## ADDENDUM NUMBER 2

**H27-6096-MJ**

**Outdoor Football Practice Felds Construction  
University of South Carolina**

LD DETAILS  
TERNATE #1  
02 OF 7  
T IN SET:  
N/A

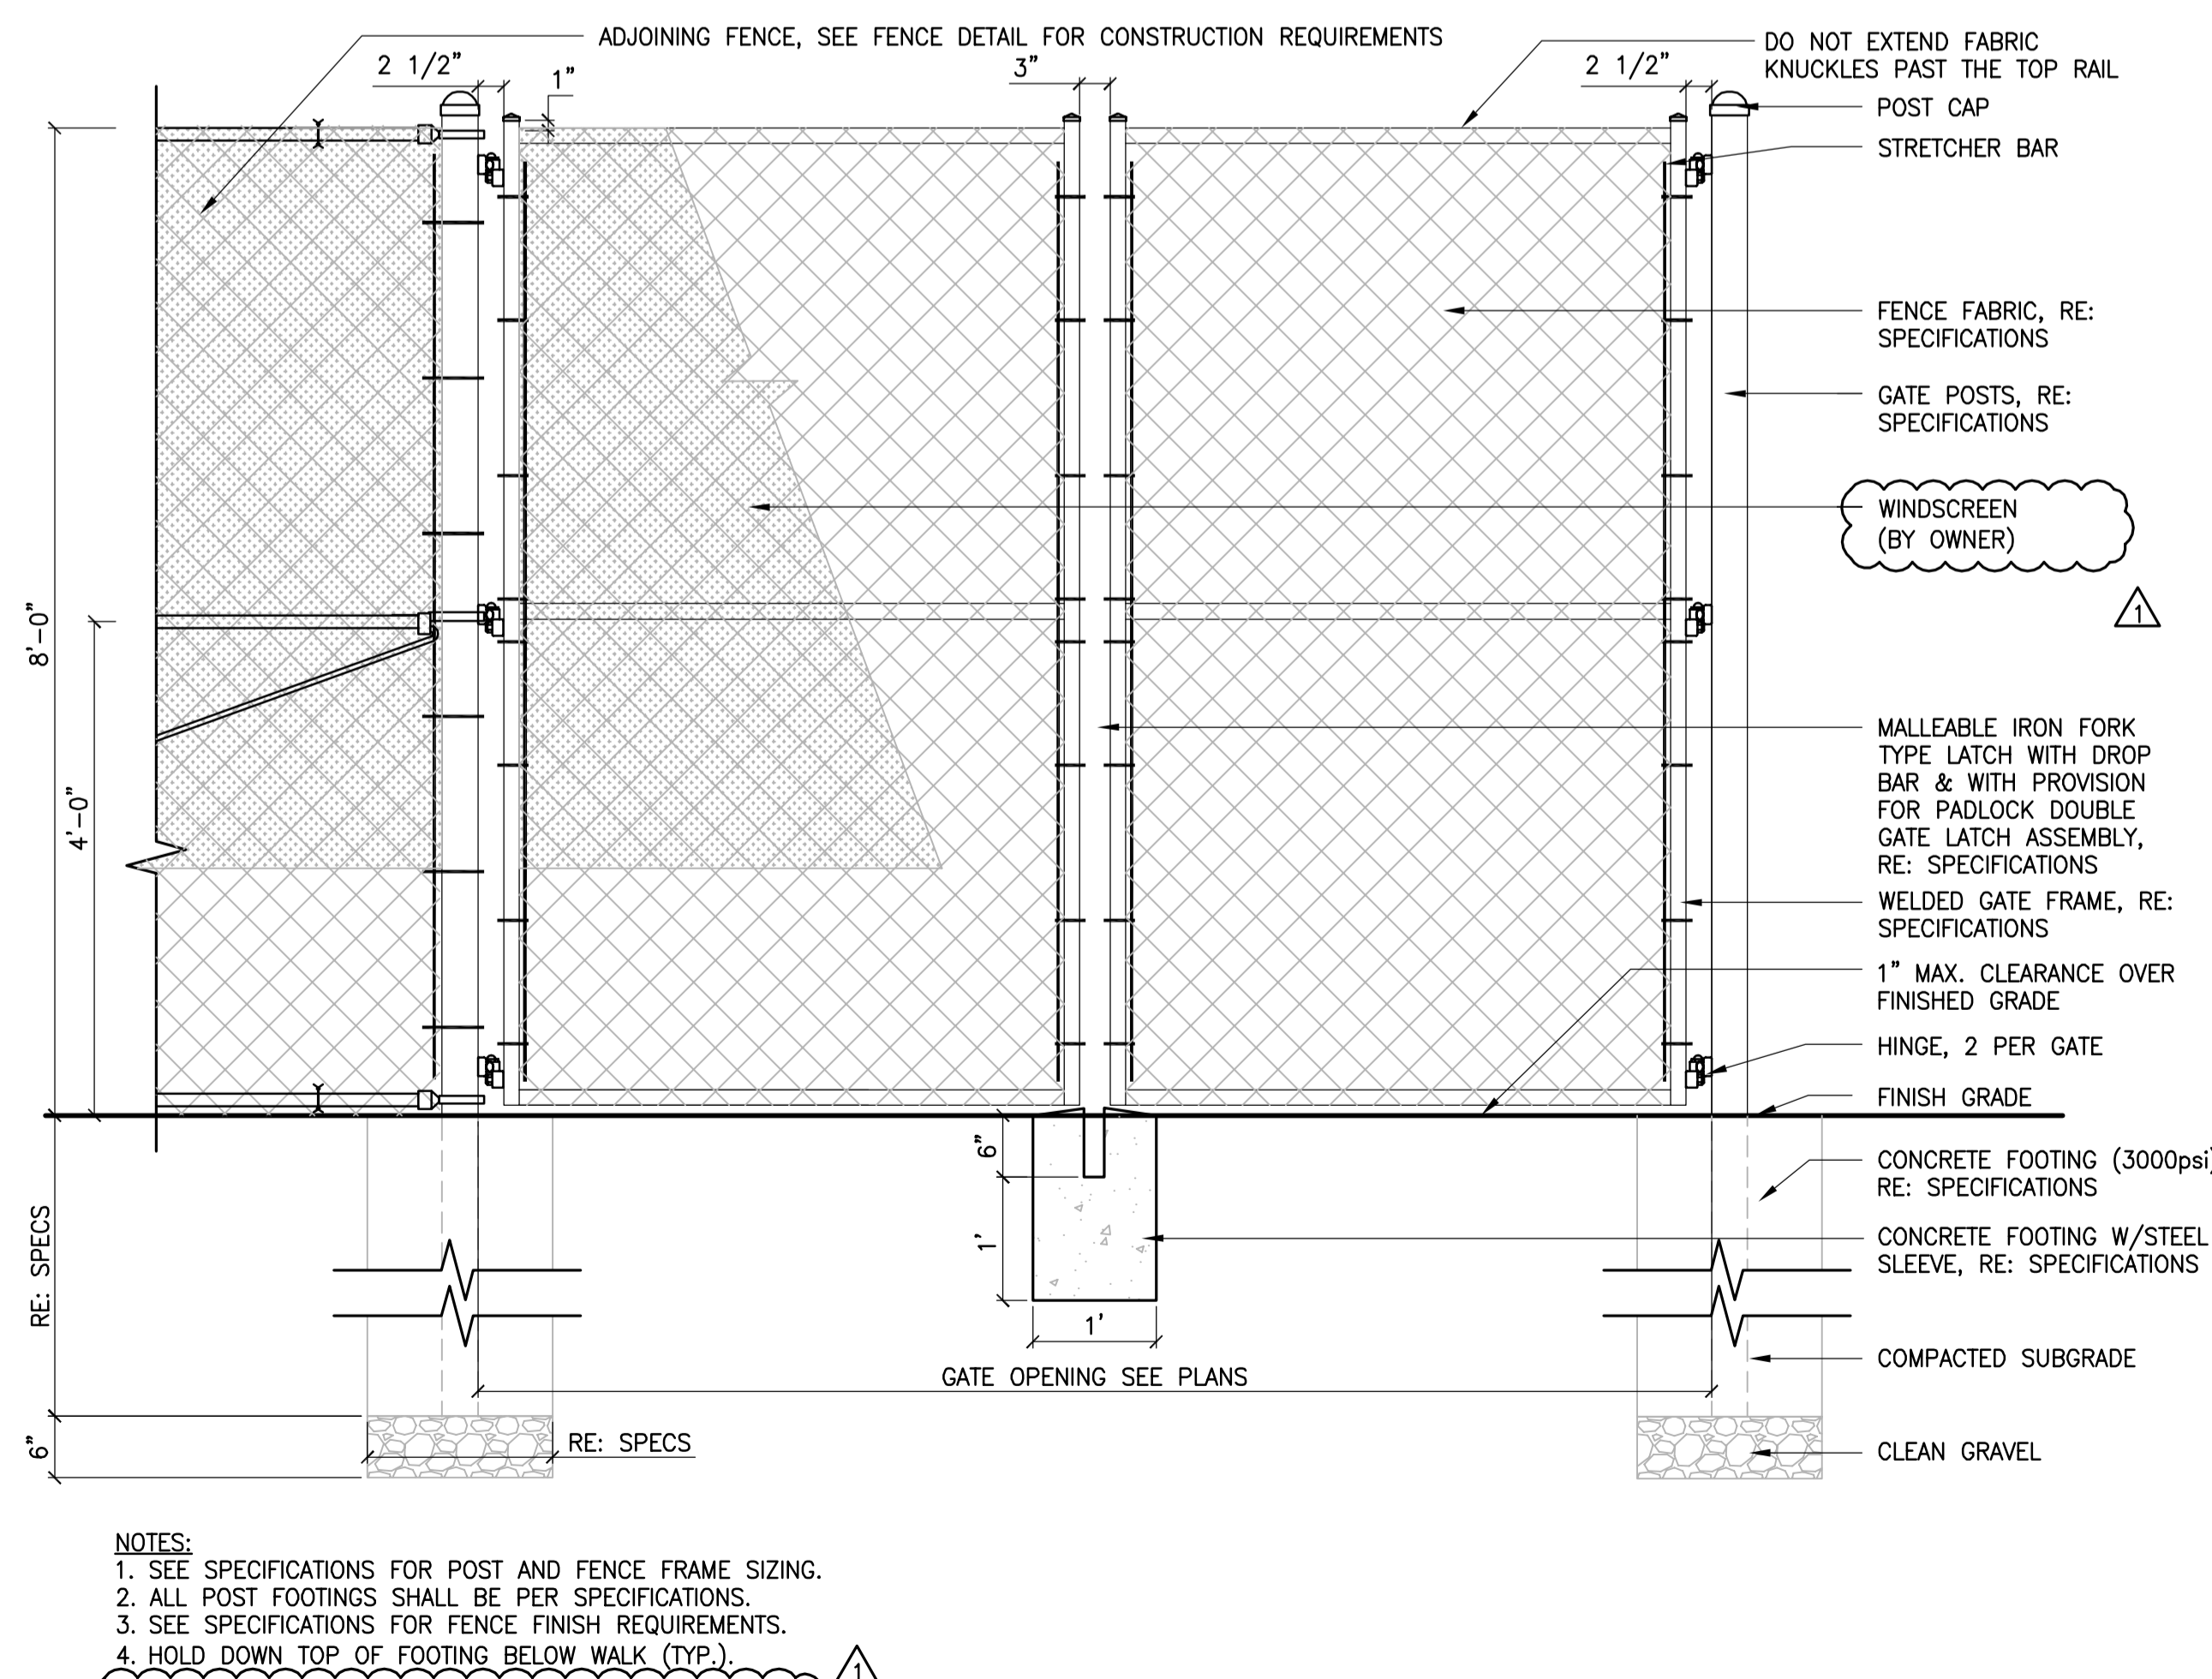
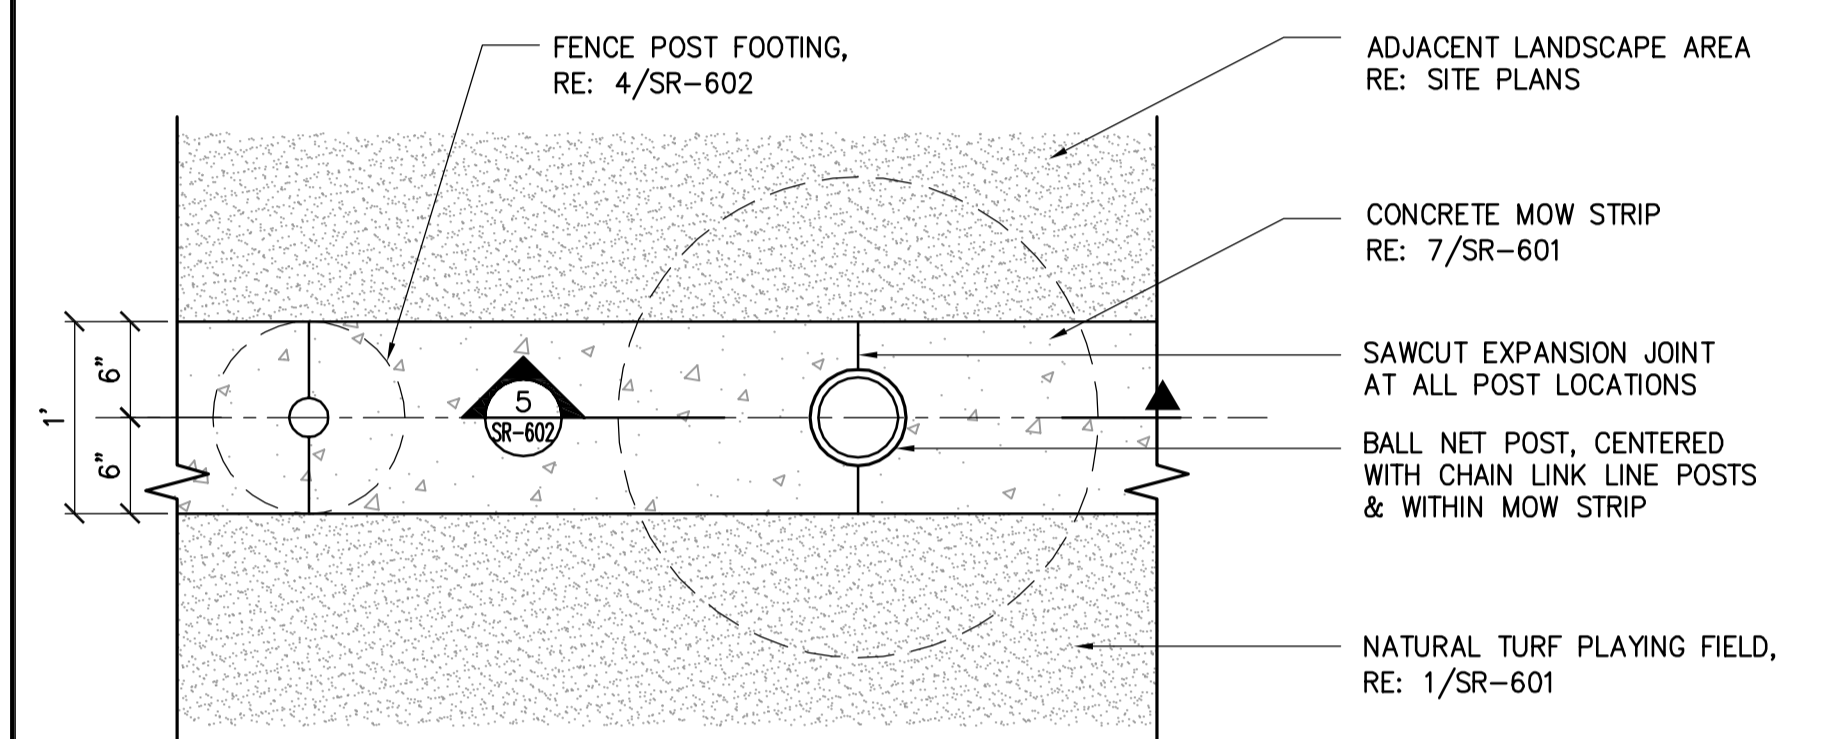
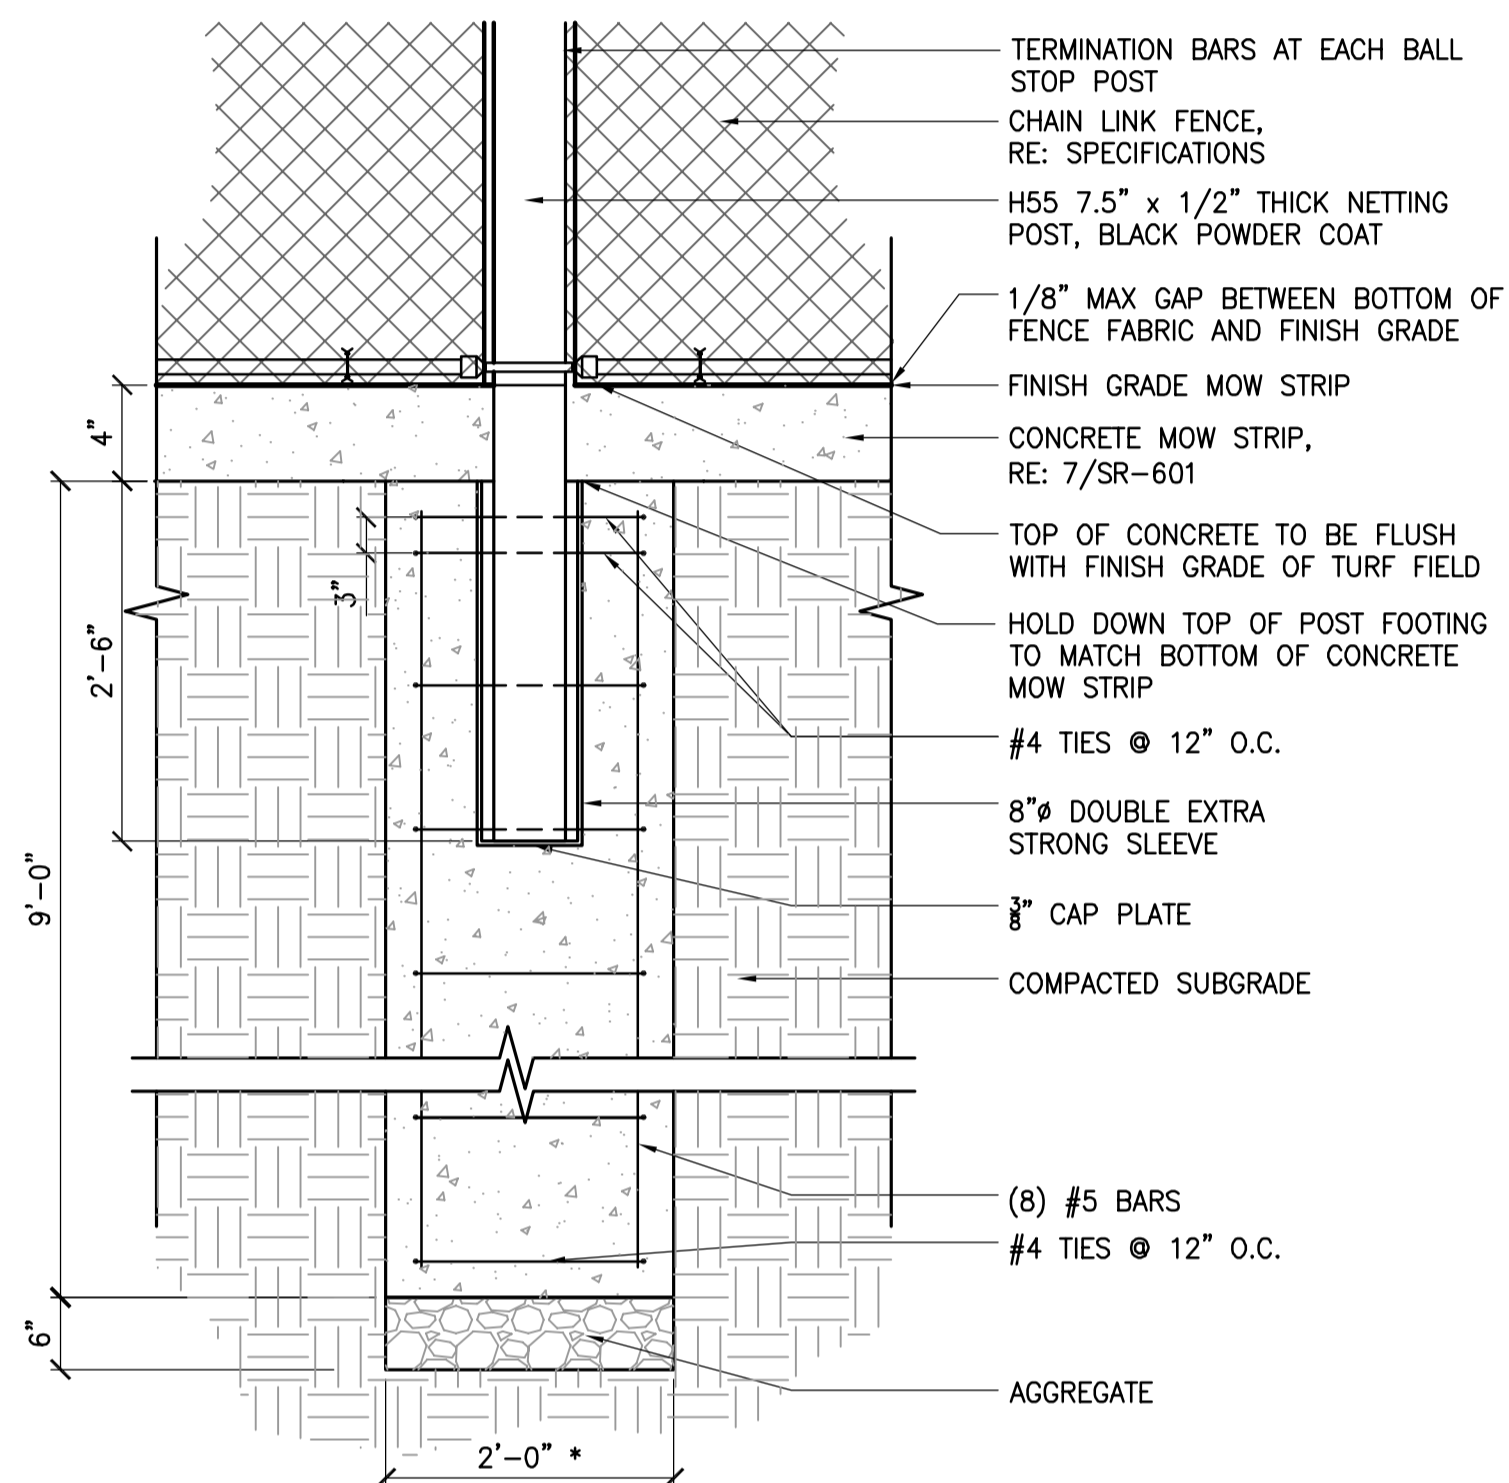
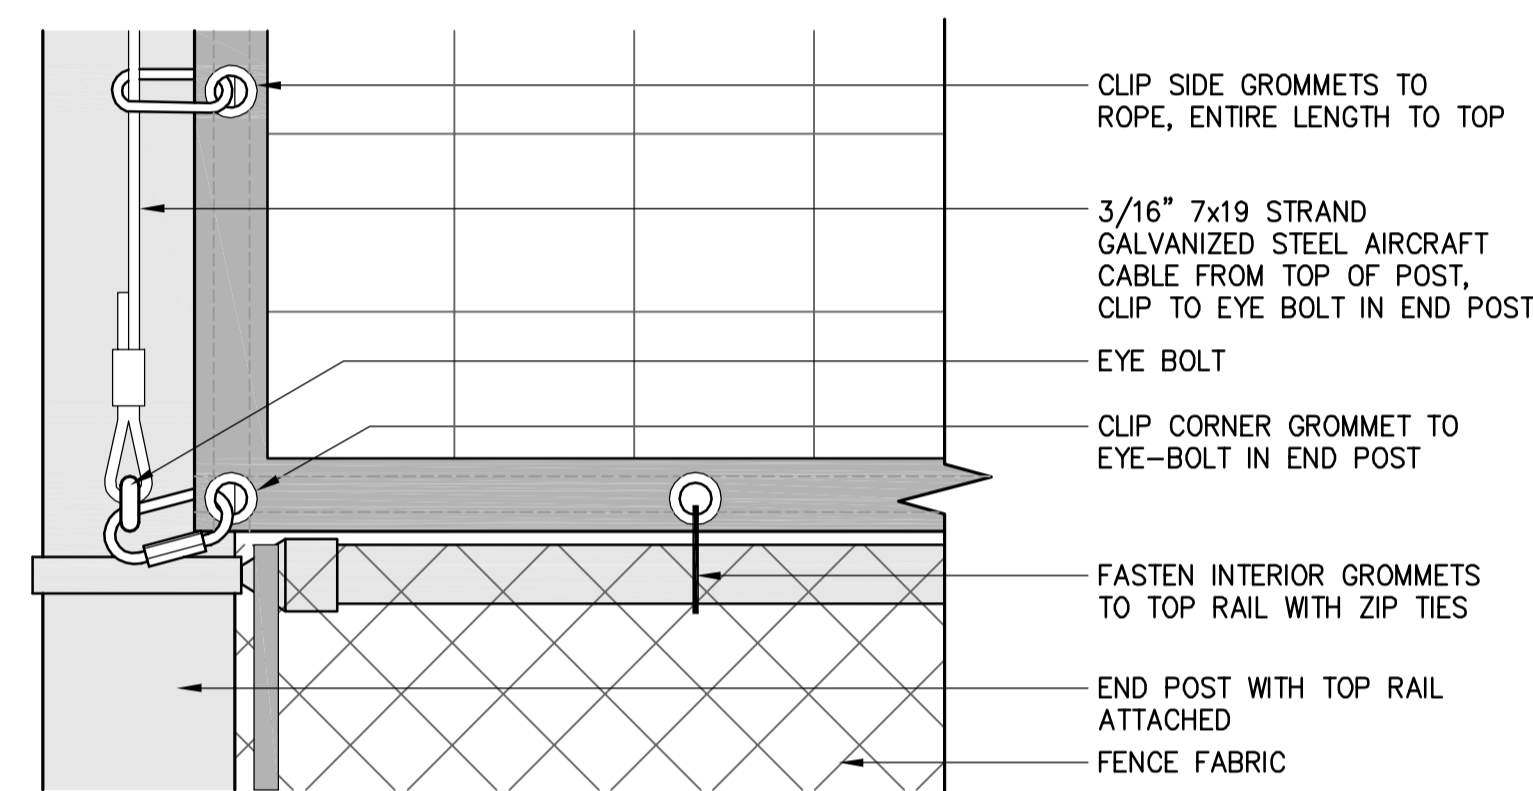
- a. Sheet SR101 - Reissued to reflect filming tower alternate #2
- b. Sheet SR601 - Reissued to include specification for elastic Curb
- c. Sheet SR602 - Reissued to reflect the wind screen provided and installed by the Owner.
- d. Sheet A 1.1 - Reissued to show filming tower base bid and alternate #2 scope of work.
